Jean Fraser - 133 York St

**From:** Erin Foley <efoley19@aol.com>  
**To:** Jean Fraser <JF@portlandmaine.gov>  
**Date:** 10/22/2013 4:47 PM  
**Subject:** 133 York St

As far as the project at 133 York Street I would like to bring up the following concerns:

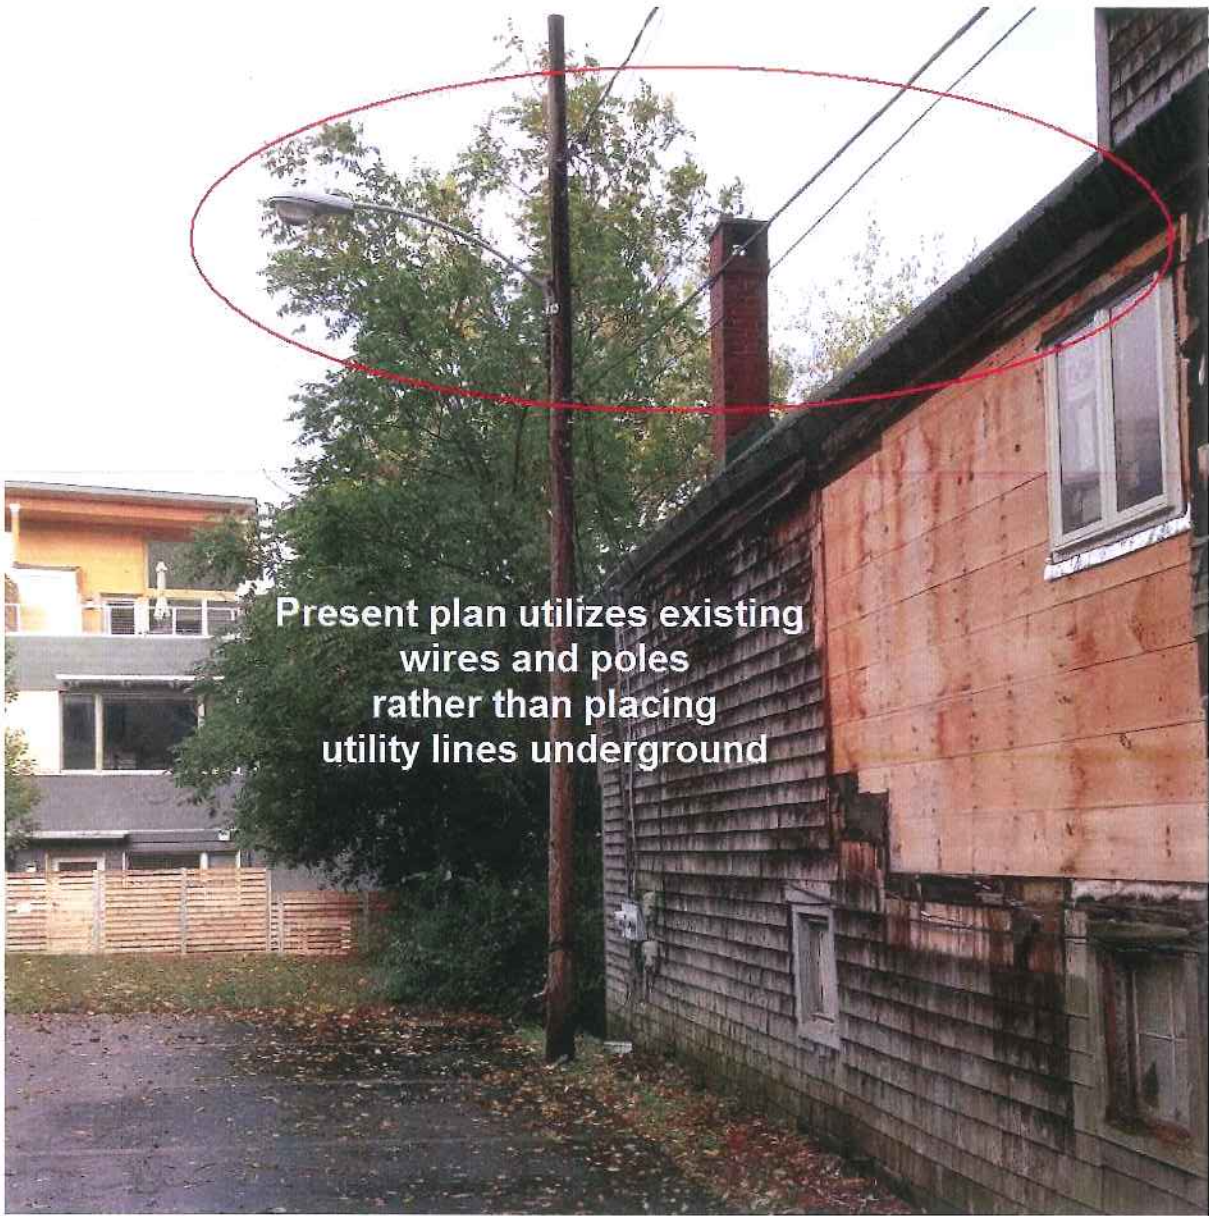
McCormick Place  
parking spaces  
are 42" from the  
edge of the existing  
building on 133 York

Photo to the right is an  
enlargement of the photo  
above showing the  
distance between the  
existing building and the  
cars parked in the  
McCormick Place  
parking lot

*Flat Roofed  
Buildings  
in Surrounding  
Neighborhood  
Shown Above*

*Proposed  
Building for  
133 York St  
to the Left*

**Present plan utilizes existing  
wires and poles  
rather than placing  
utility lines underground**

2. This building does not fit in with the feel of the neighborhood. According to R-6 Design principles and Standards " A building design shall contribute to and be compatible with the predominant character-defining architectural features of the neighborhood" "they have a public responsibility to add to and enhance the neighborhoods in which their projects are built." This building is less than 100 feet from the historic district and within the West End. Most homes within the neighborhood maintain historic qualities or make an effort to blend in with the feel of the neighborhood. See image 2 .

This related to our parking spaces, where due to safety reasons, I believe we will not be able to use the 5 spots abutting the construction site. Currently there is less than 4 ft from our parking lot to their property. See image 1.

See image 3 and 4.
